Mobile Intel[®] Celeron[®] Processor at 466 MHz, 433 MHz, 400 MHz, 366 MHz, 333 MHz, 300 MHz, and 266 MHz Specification Update

Release Date: June 2002

Order Number: 244444-033

H29. Thermal Sensor May Assert SMBALERT# Incorrectly

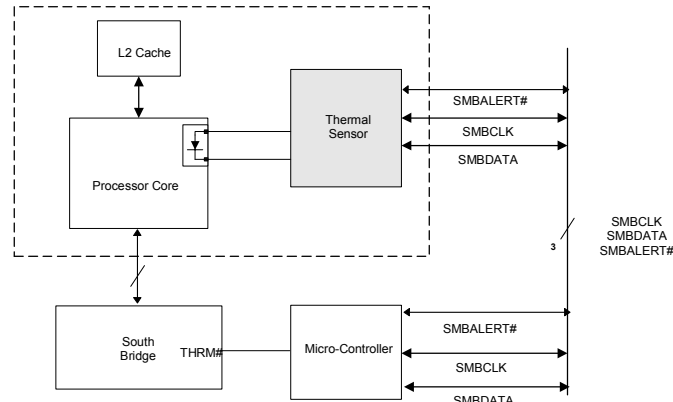
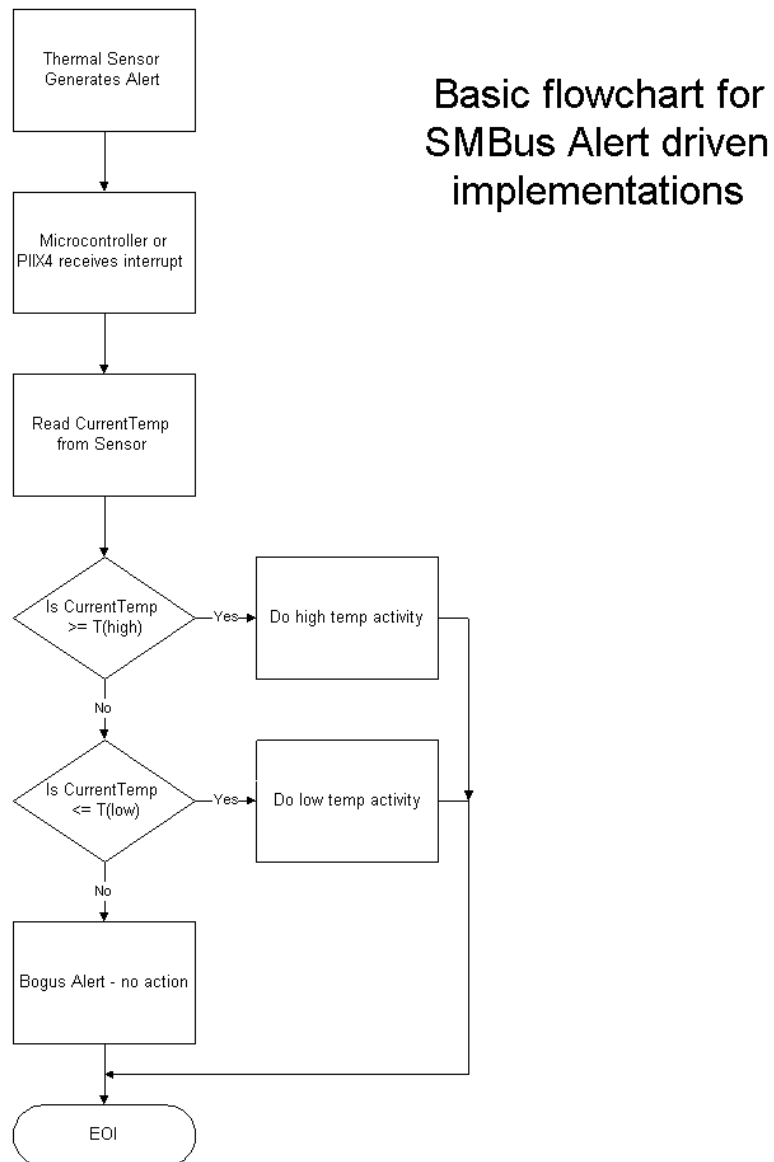
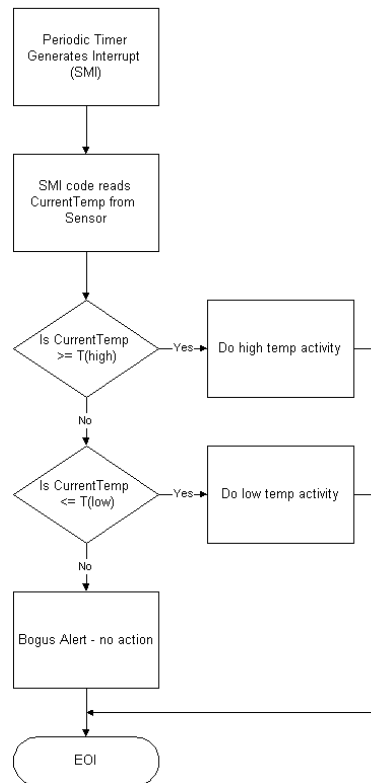
Problem: The Intel Celeron Processor Mobile Module has a thermal sensor that monitors the processor core's temperature. Please note that desktop systems could have a similar thermal device. The thermal sensor asserts SMBALERT# if the processor temperature exceeds the temperature limits set in the Alarm Threshold Registers (T_{HIGH} , T_{LOW}). It also sets the corresponding Status Register bits to identify the cause of the interrupt. Figure 1 gives one example of how the SMBALERT# signal could be used in a system.

Implication: There is no system impact from this erratum if temperature polling is used for processor thermal management. If the SMBALERT# interrupt is employed to manage processor thermal sensing, then servicing the false interrupt may result in premature system action depending on the software and hardware implementations used. The rate of the false interrupts is less than the auto-convert rate of the thermal sensor.

Workaround: Three different (mutually exclusive) workarounds are possible:

1. Before servicing an interrupt from the thermal sensor, read and compare the processor thermal reading with the threshold limits (T_{HIGH} or T_{LOW}). Figures 2 and 3 provide basic flowcharts for the implementation of this workaround in an interrupt driven system.
2. If the firmware implemented polls the Status Register only, then before taking any action, re-read the temperature register and do a comparison with the alarm threshold limits (T_{HIGH} or T_{LOW}) to determine if the value is actually still within the temperature window.
3. Use a temperature polling scheme to monitor the processor temperature.

Figure 2. Workaround Flowchart: SMBALERT#-Driven System

Figure 3. Workaround Flowchart: SMI#-Driven System
